BRACKETT BA-2410 ASSEMBLY CONFIG

DATE: 1-24-03 R1

AD 2002-26-03
 Amend 39-12988

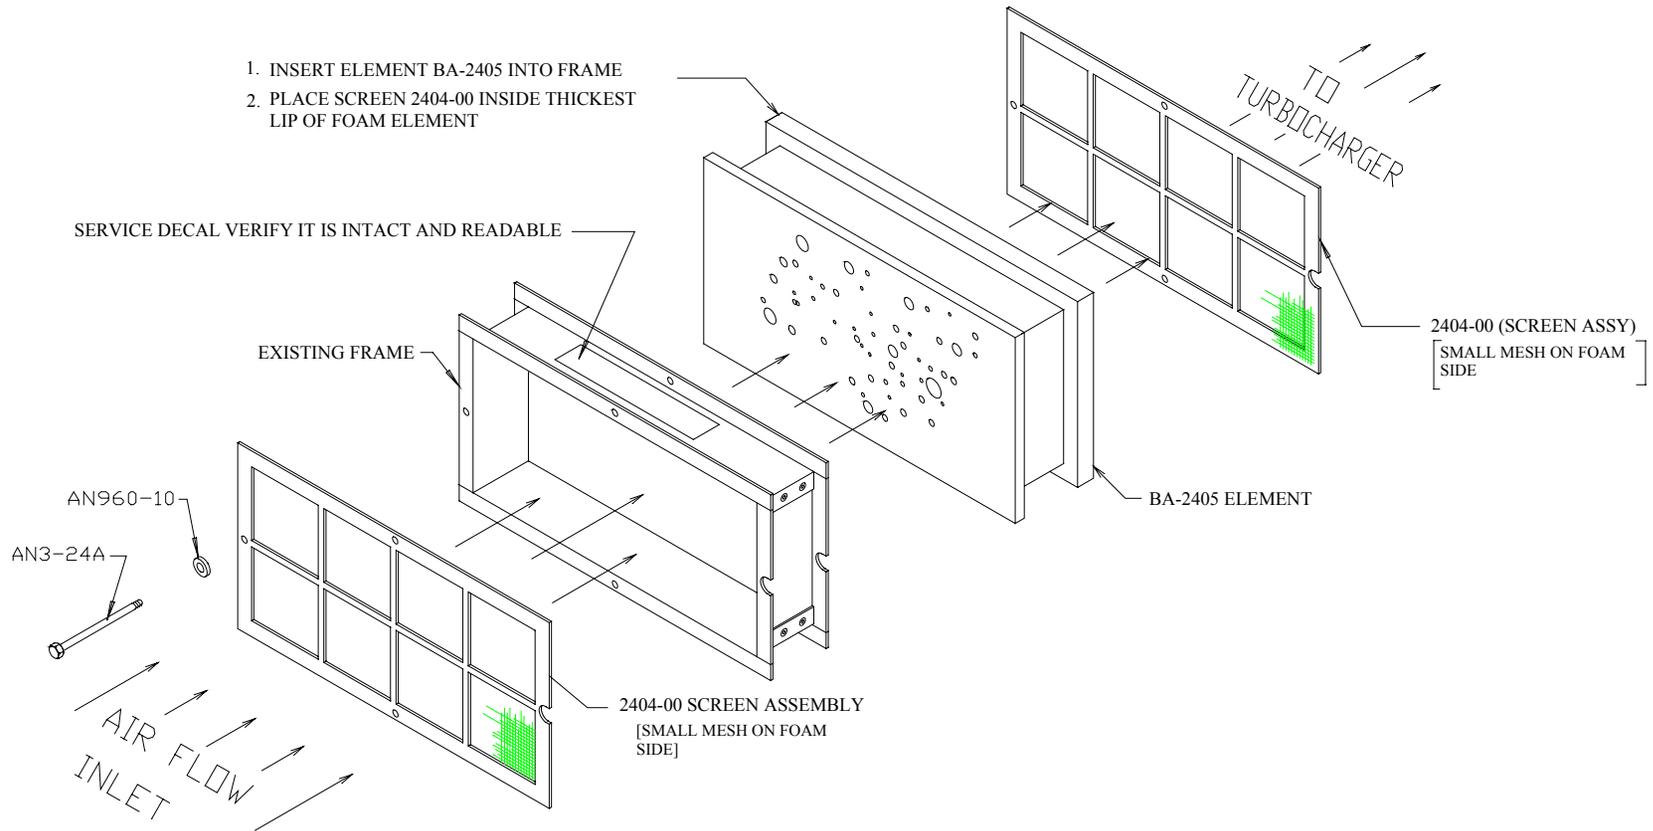
NOTE: The 2 screen configuration has been produced from 1994 and on. The filter assemblies prior to 1994 require an additional screen installed. The screen style changed from the pre 1994 style, as a manufacturing update. The latest screen assembly P/N 2404-00 is slightly thinner making easier to install into the element pocket on the downstream side but, will work either way.
